RANCHO SANTIAGO COMMUNITY COLLEGE DISTRICT

ADDENDUM NO. 2

Bid #1506
ORANGE EDUCATION CENTER PORTABLES PHASE II
at
ORANGE EDUCATION CENTER

Project ID #3762, DSA #04-125366

5 WAYFINDING SIGN 05
Scale: 3" = 1'-0"

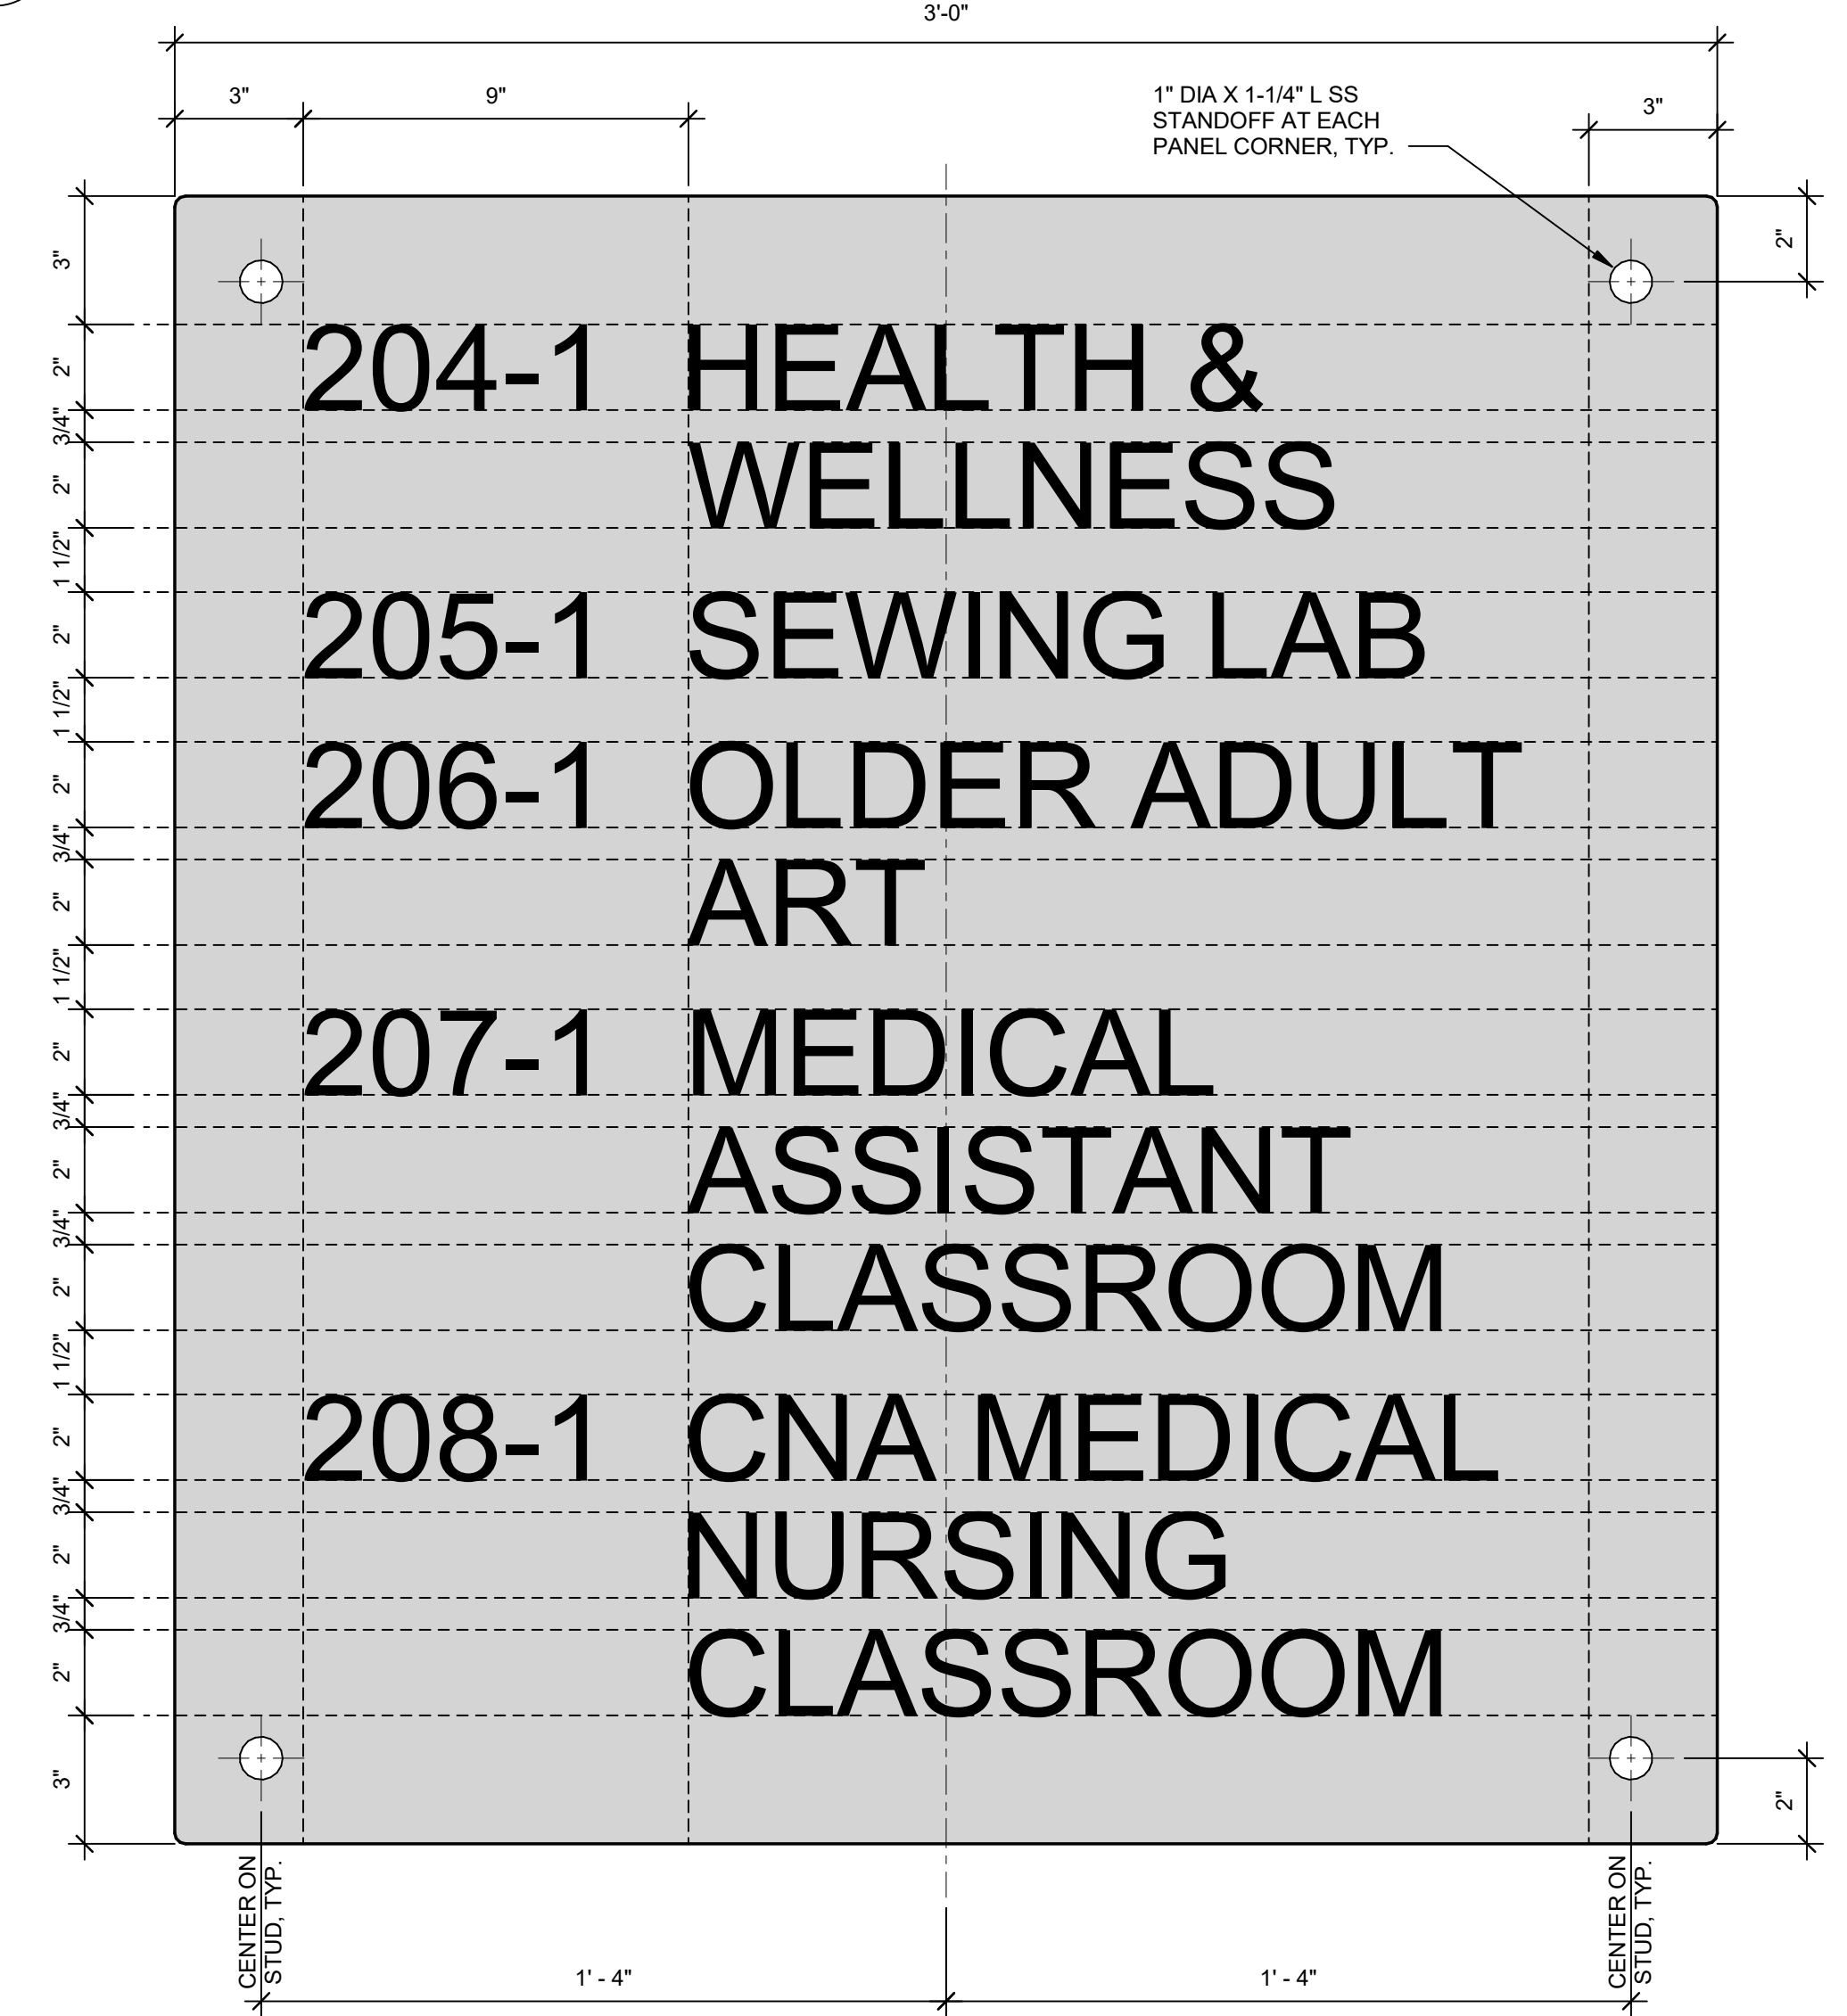
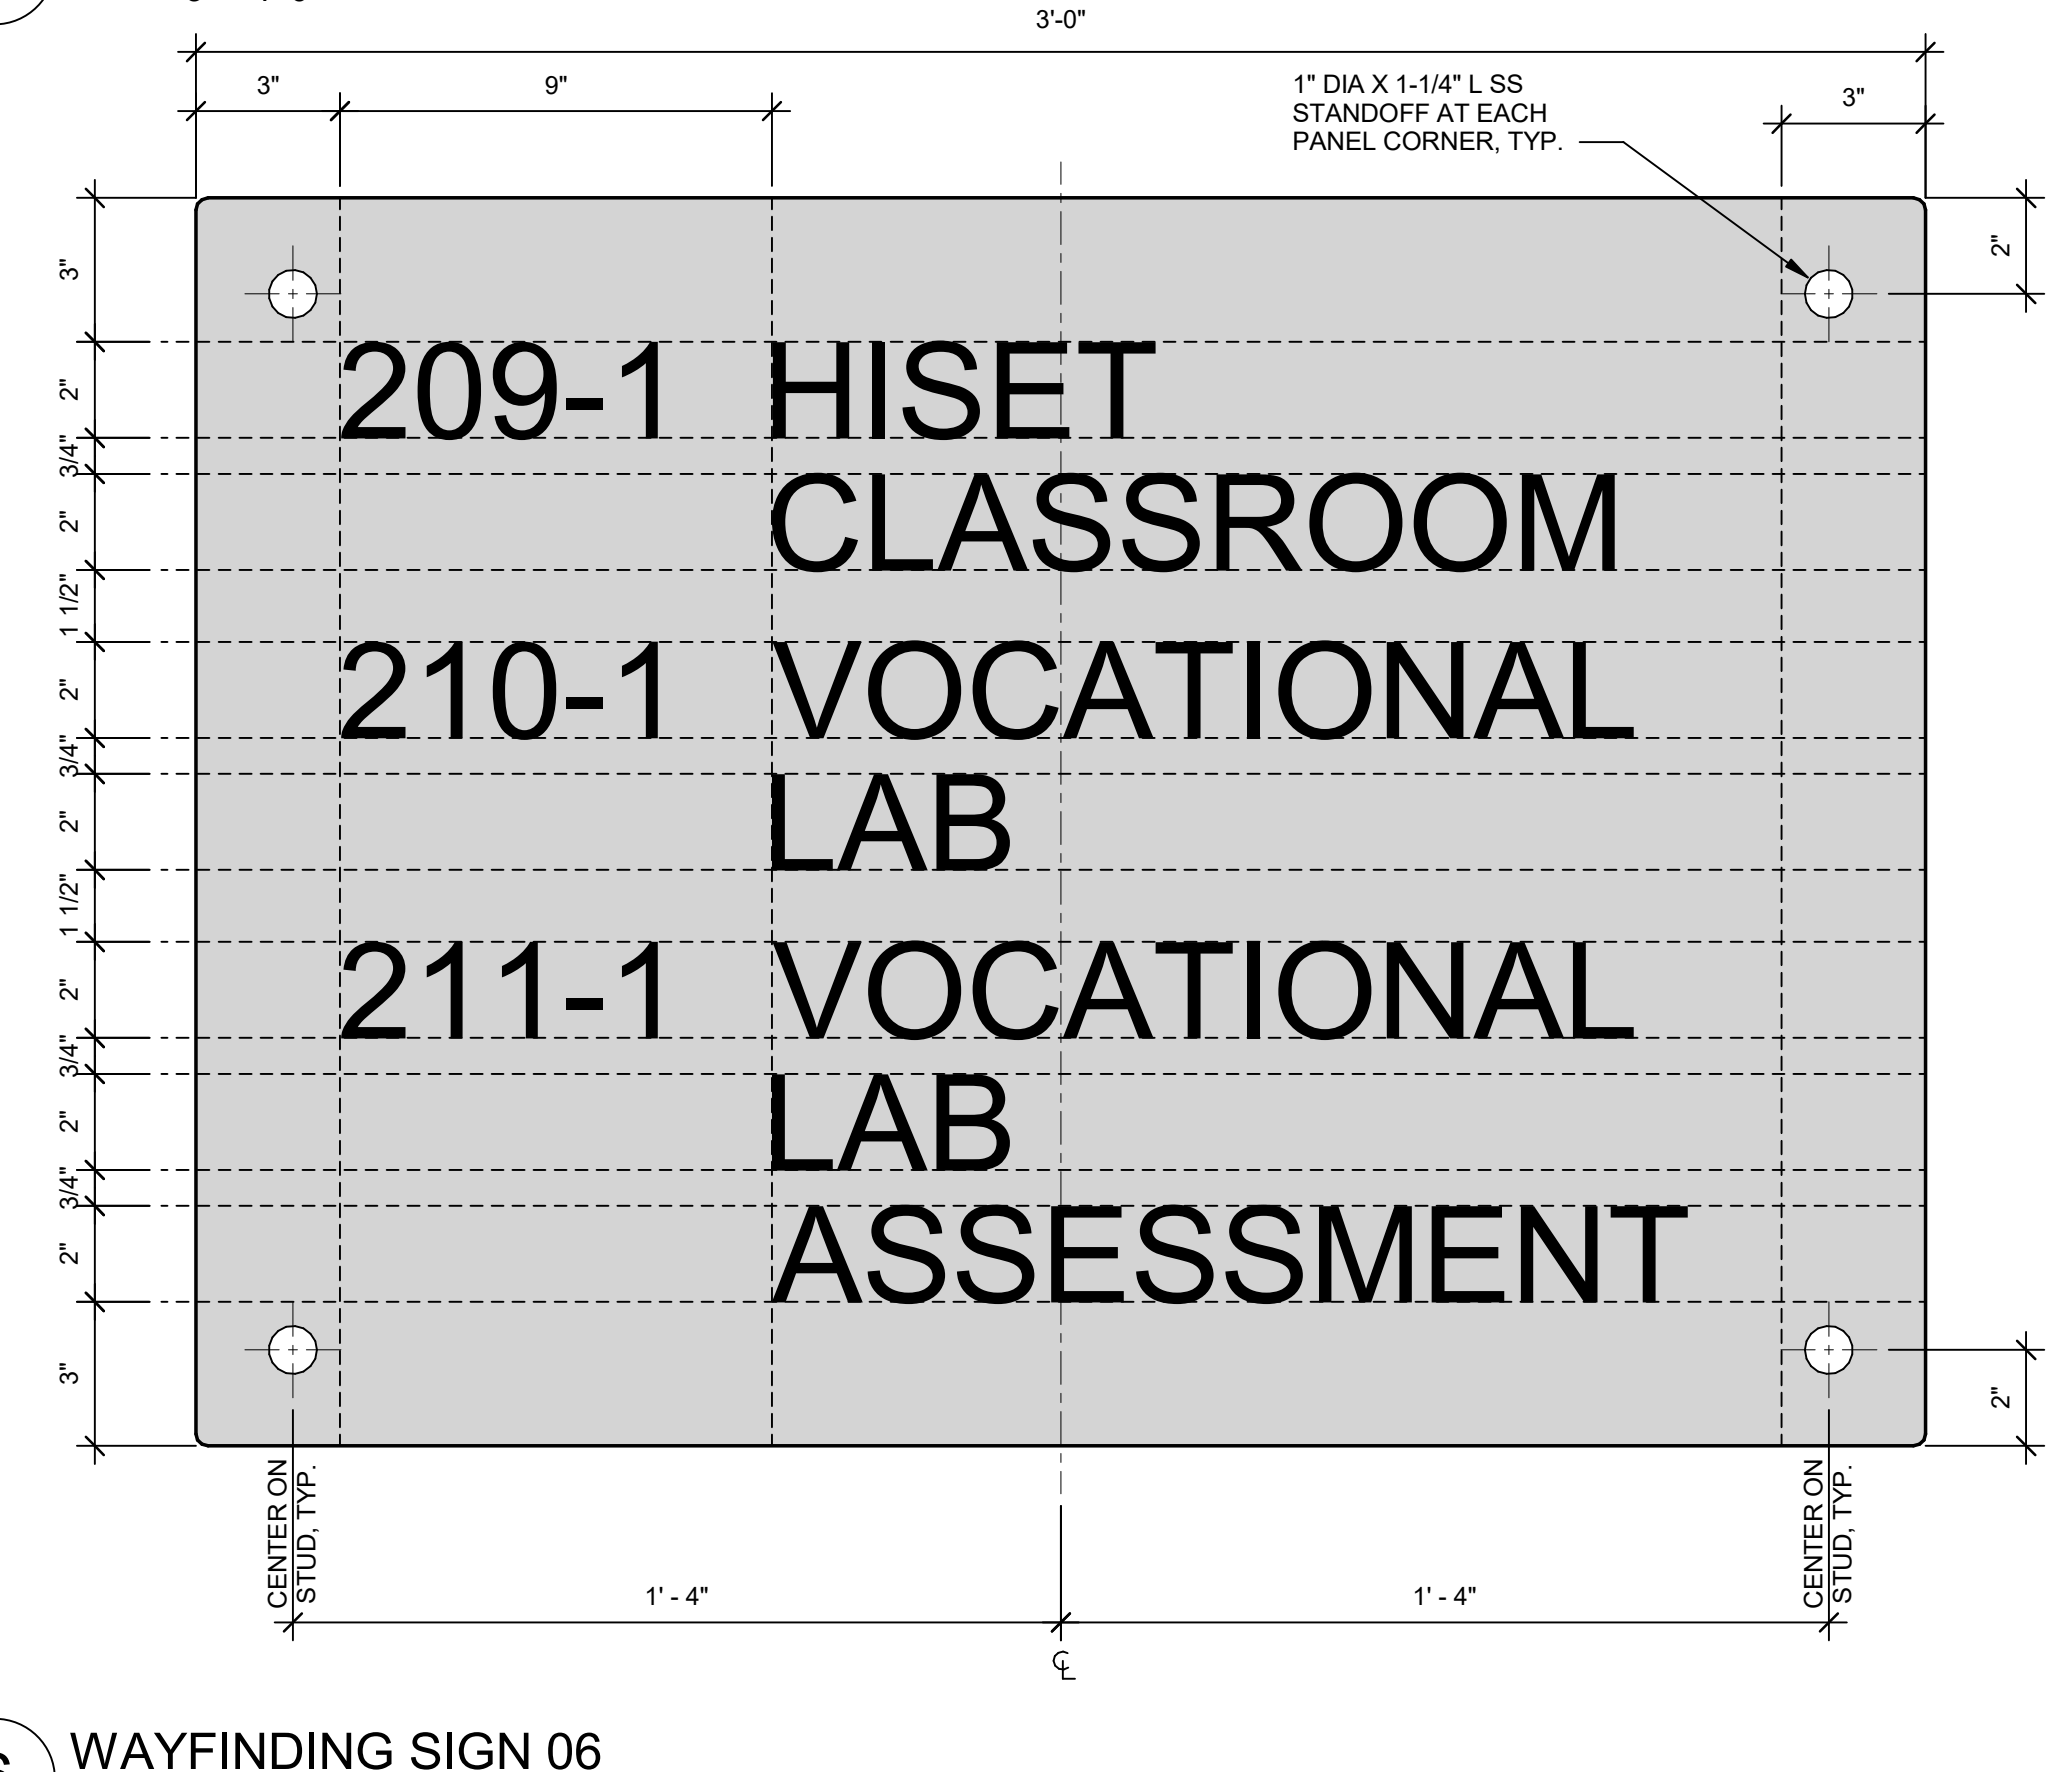
6. A6.02-2, WAY FINDING SIGNAGE DETAILS

Added Addendum Dwg. A6.02-2, Way Finding Signage Details

CMA440

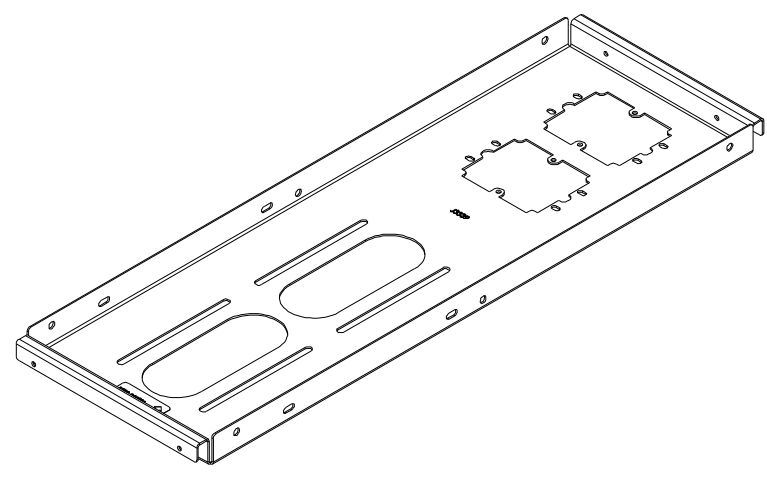
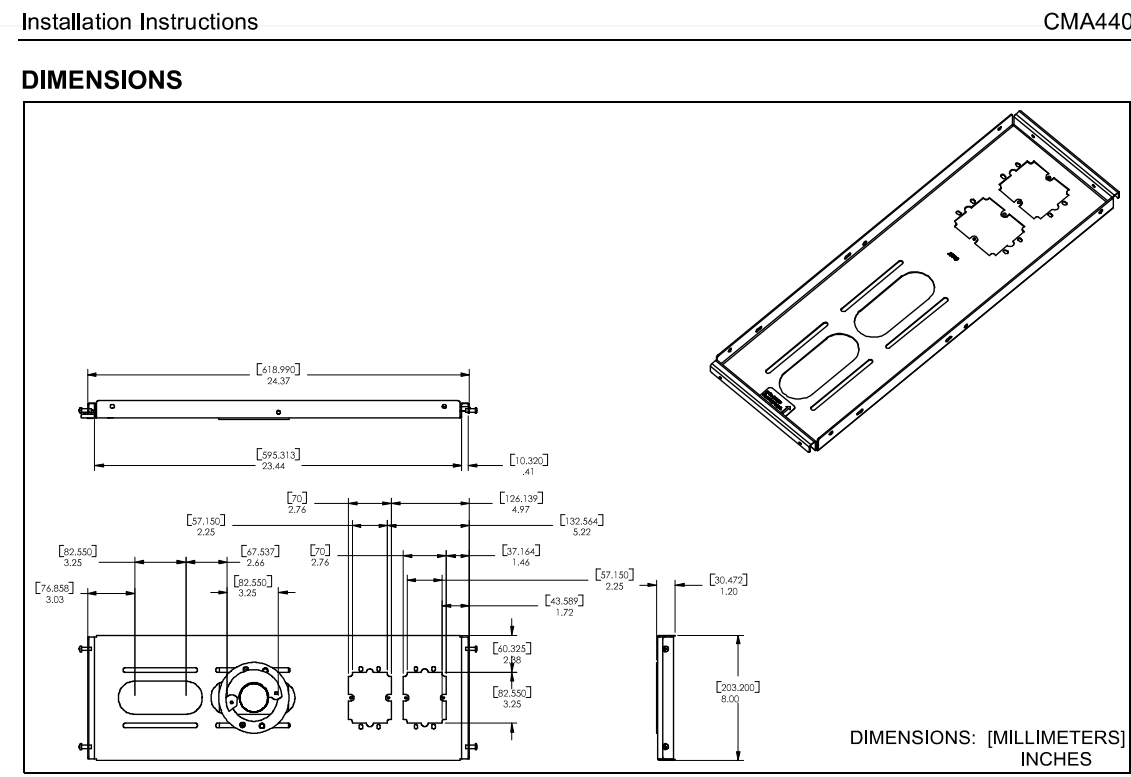
8. **A7.07-2, INTERIOR DETAILS**

Omitted Detail 7. Replace with CHIEF CMA440 as per attached manufacturer cut sheets
